Ayesha Fashion Limited

06 February 2023

Buildings Information

Load plan (6 KPa)

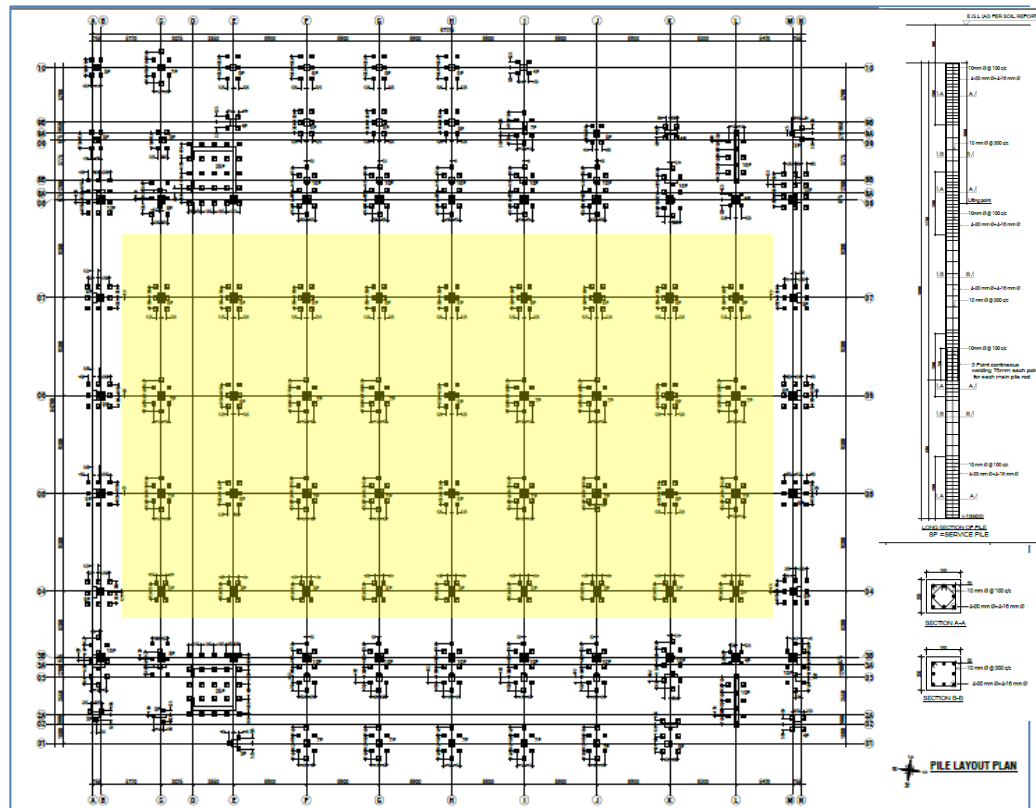
Cursory calculation indicates internal steel columns stressed above normal design limit

The cursory calculation indicates that internal columns stress exceeds the normal design limit considering a typical floor live load 6 kPa, and minimum tensile strength of steel plate 250 MPa. The building engineer is required to review the design, loads, and column stresses.

Bolt missing and connection gap

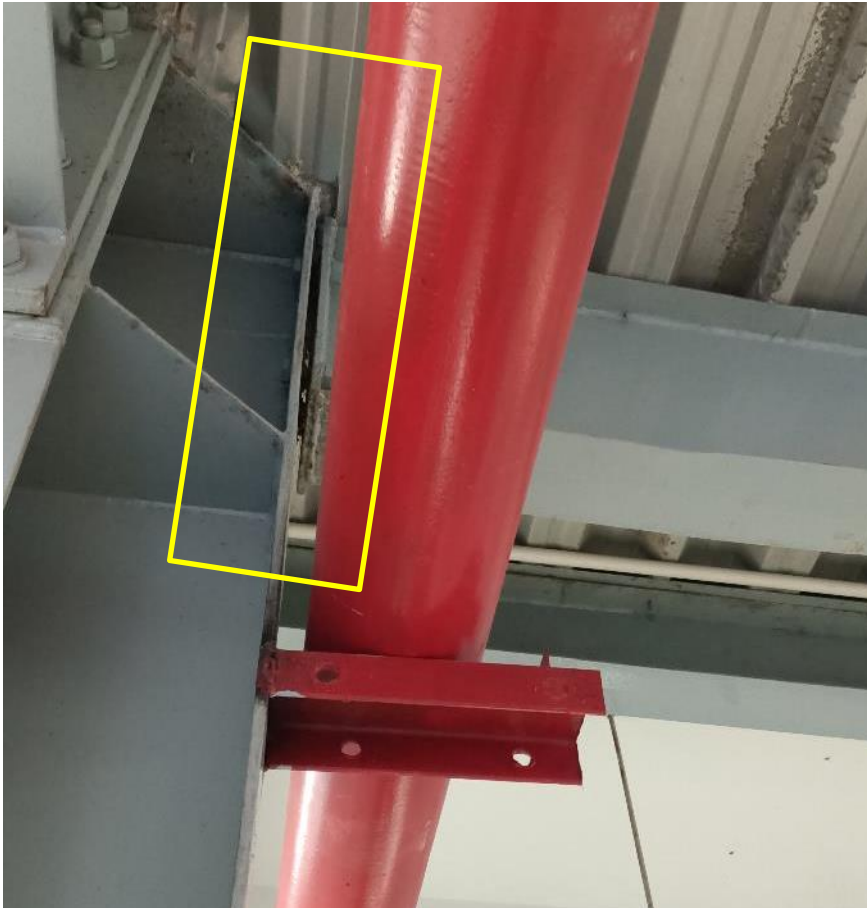
Bolt missing and significant gaps observed in beam-column joint at several locations. Building engineer is required to carry out suitable remedial works.

Gap observed in connections

Bolt missing

Corrosion in steel member

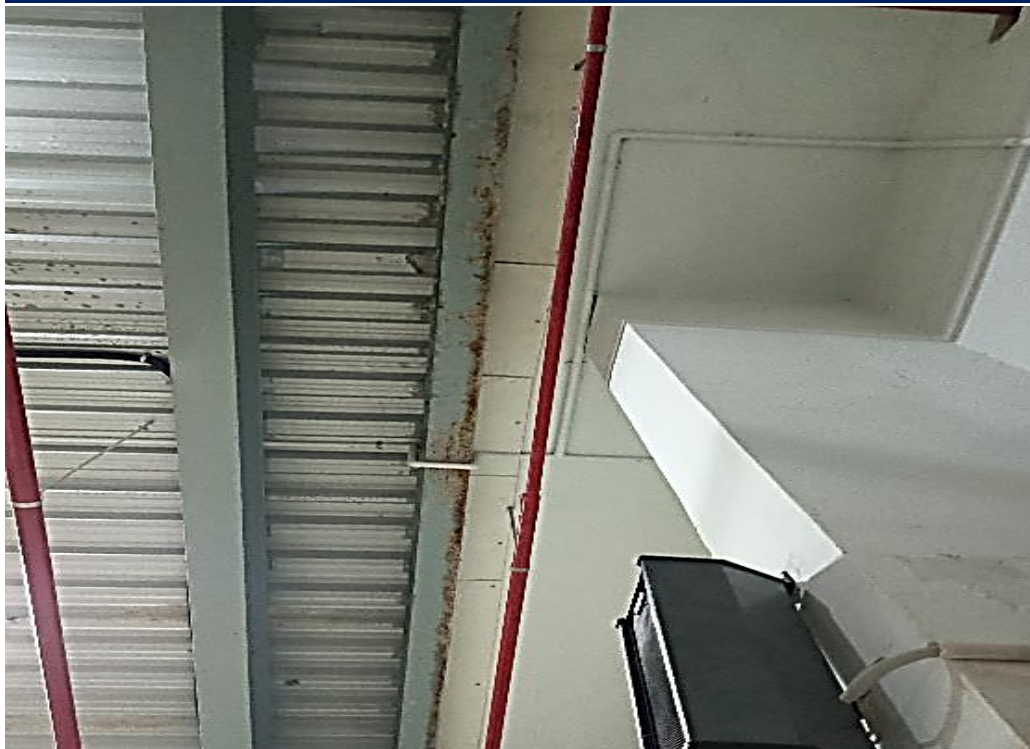
Corrosion in steel member of staircase was observed in the several locations. The building engineer is required to suggest proper remedial measure accordingly

Soil test report

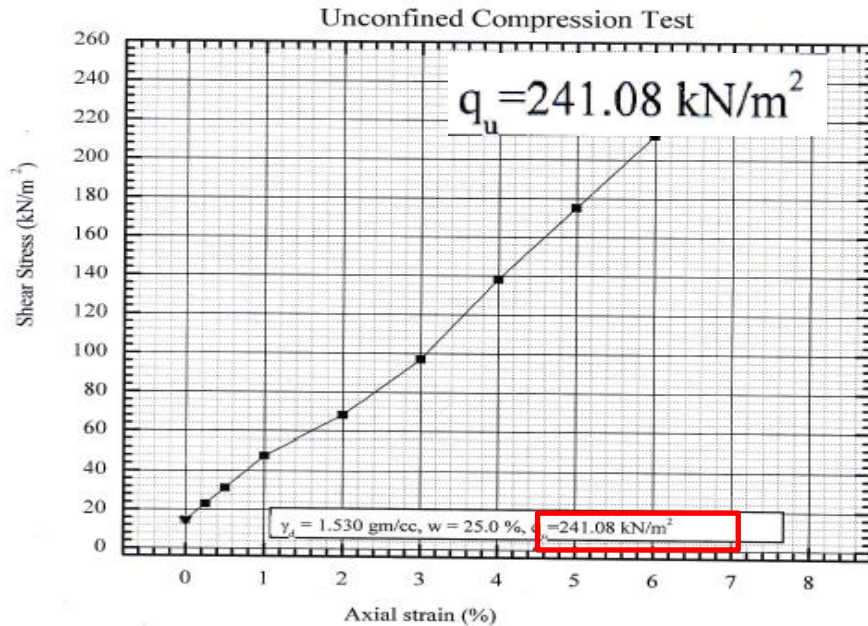
Design report need to be revised

Foundation capacity required to revise in the design report. As per provided soil test report $q_u=241.08$ KN/m² but in the design report $q_u = 400$ KN/m² considered for pile capacity calculation. Moreover, Serviceability and irregularity check was not found in this design report.

Building engineer is required to revise the design report for foundation calculation and submit to RSC.
